Ananta Jeans Wear Ltd. (Extension)

12 March 2023

Building Information

Isolated foundation layout plan

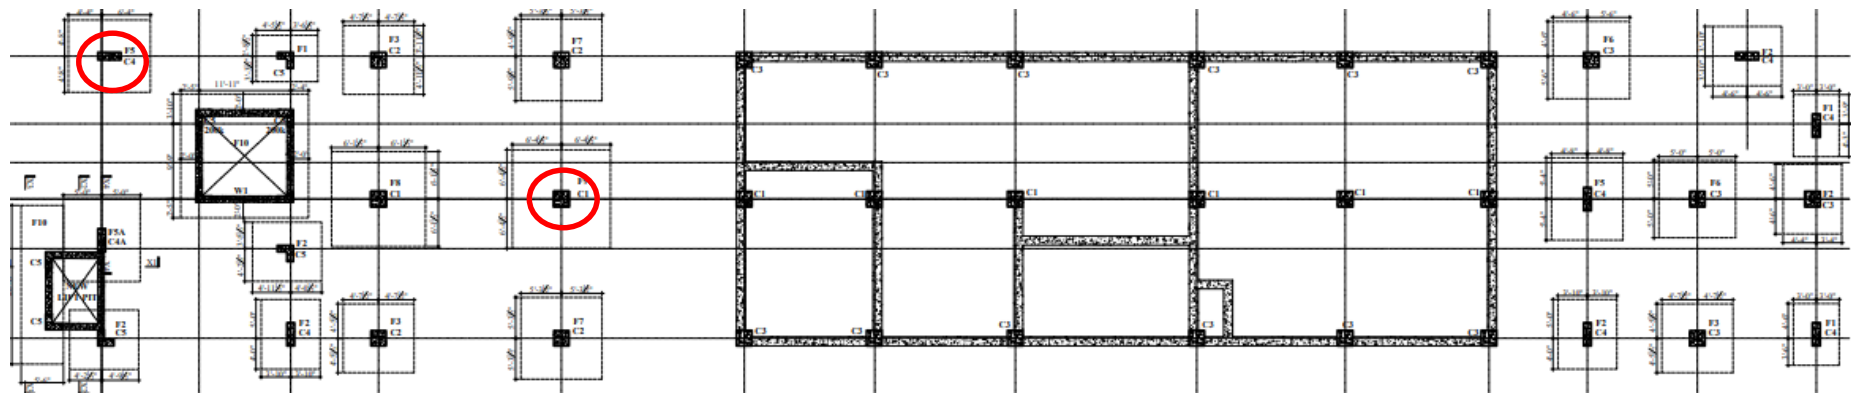
The cursory calculation indicates that footings are stressed above the normal design limit considering the average soil bearing capacity 1.53 kg/cm² (FS 2.5) recommended in the geotechnical investigation reports. Building engineer is required to review the foundation stresses of the area identified above.

3.2 MATERIALS CONSIDERED IN DESIGN

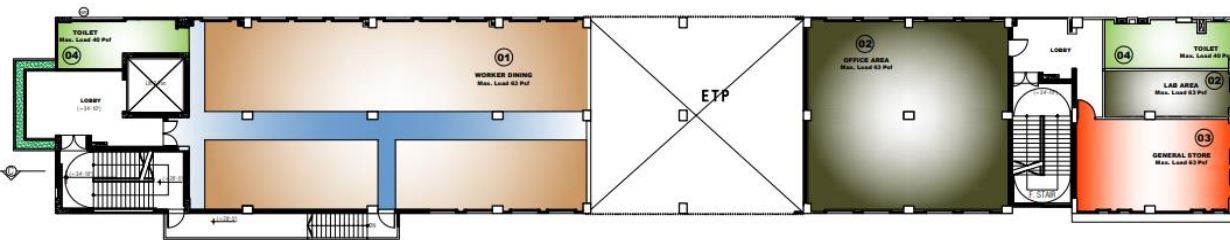
Concrete compressive strength f_c' considered 4000 psi (27.5 MPa) in the design. Adequate number of concrete cylinder test report was not available onsite as per BNBC. However, the building engineer is required to verify in-situ concrete strength by taking core from lower tier columns.

Beam Layout of 2nd floor level (At level +34'-10")

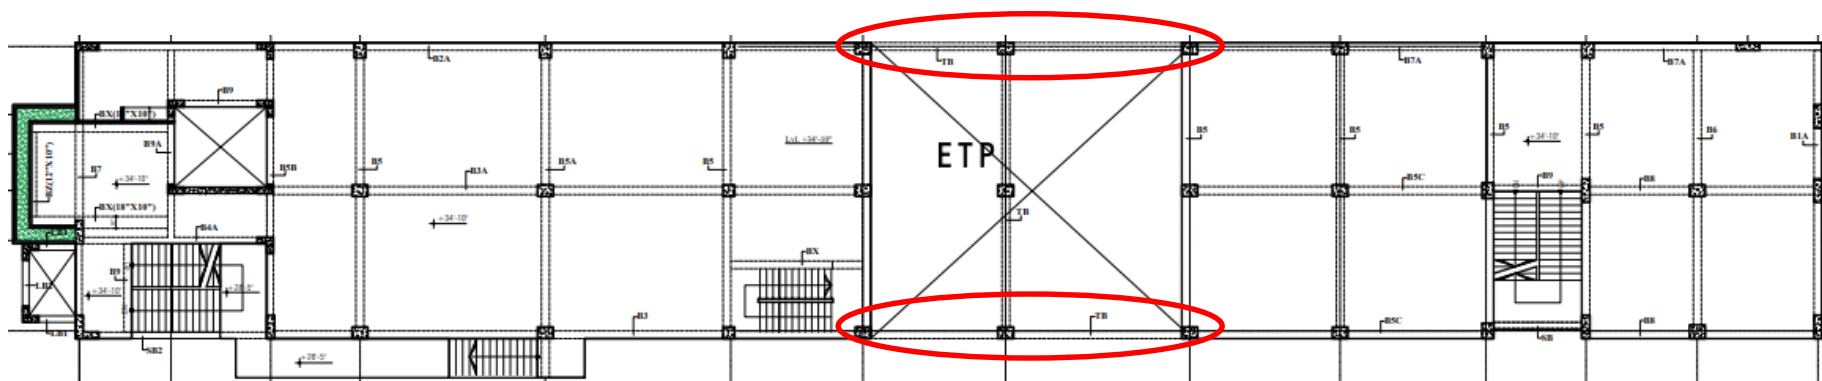
During inspection, 4 number of tie beams were found missing at level 34'-10" (10.62 m), which is marked in the beam layout. Building engineer is required to survey the full structure and produce an accurate as-built drawing and review the design accordingly.
